## North West Rapid Transit (FTAA-2511-1146)

### Comments to Panel on behalf of Cabra Industrial Limited, Cabra Fred Taylor Limited and Foundry Industrial Limited

Extent of Designation 1484 Spedding Road Extension overlapping [REDACTED]

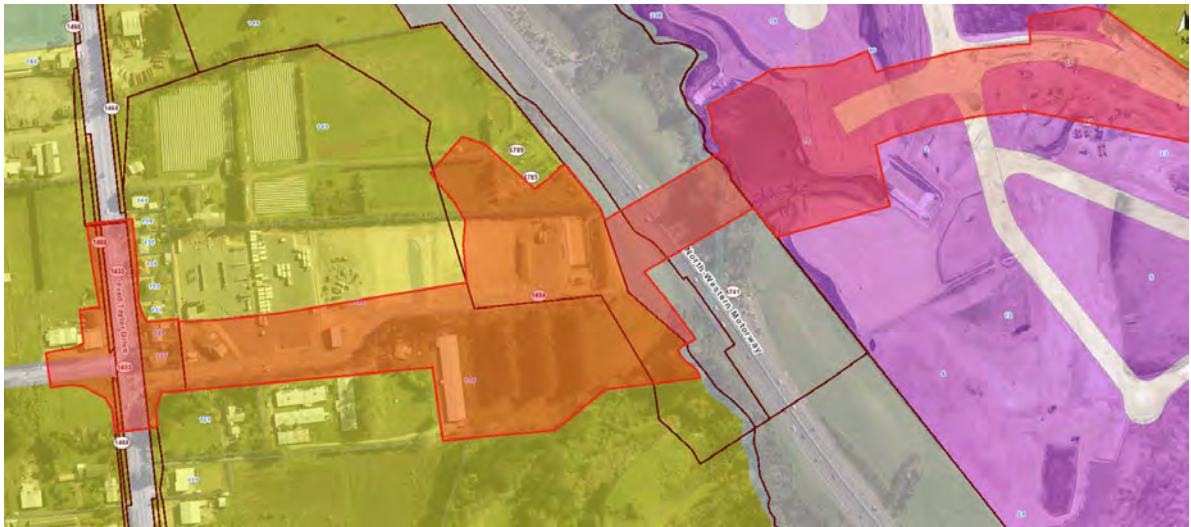
- Auckland Transport Designation 1484 (The construction, operation and maintenance of an arterial transport corridor (Spedding Road)) relates to the extension of Spedding Road to connect with Fred Taylor Drive, including a bridge across SH16. Designation 1484 is located across parts of [REDACTED], overlapping with the proposed NOR for the busway and ancillary stormwater management pond. It is unclear how the Spedding Road bridge and extension, and the busway and stormwater pond, will physically overlap or interact. How does the busway design accommodate the bridge in terms of levels, battering and retaining? The application does not appear to address this.

Extent of Designation 6785 ASH overlapping 119 and 125 Fred Taylor Drive

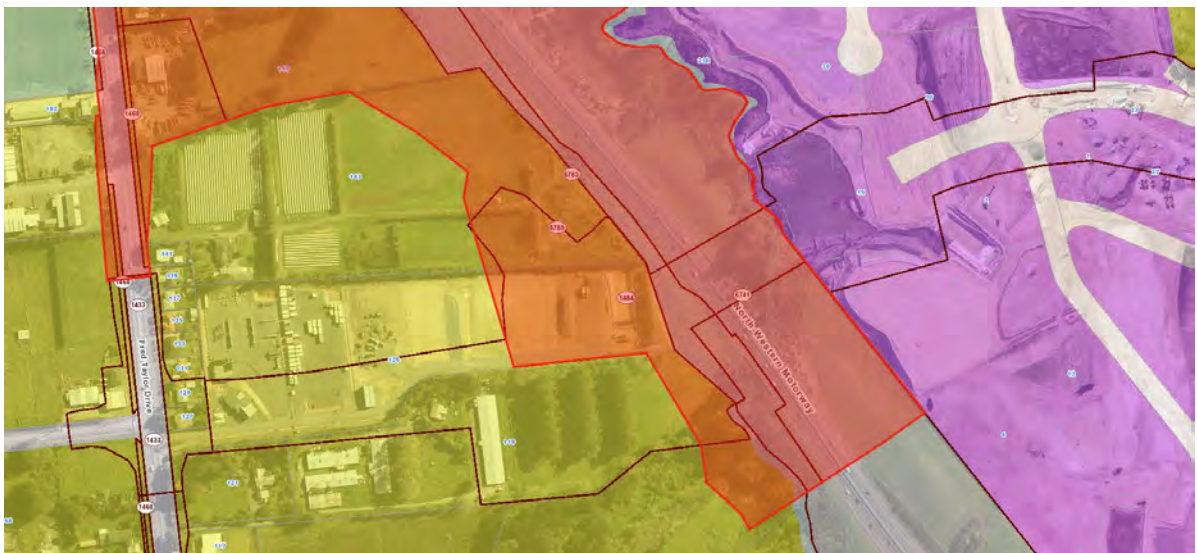
- Similarly, NZTA Designation 6785 ASH and Designation 6789 RTC overlap the eastern end of [REDACTED]. It is unclear how the design of the Busway integrates with these significant transport projects. The same issues arise as set out above in respect of the Spedding Road extension, however unlike that project, the ASH and RTC are not prerequisites for growth and development in Whenuapai West (refer below).
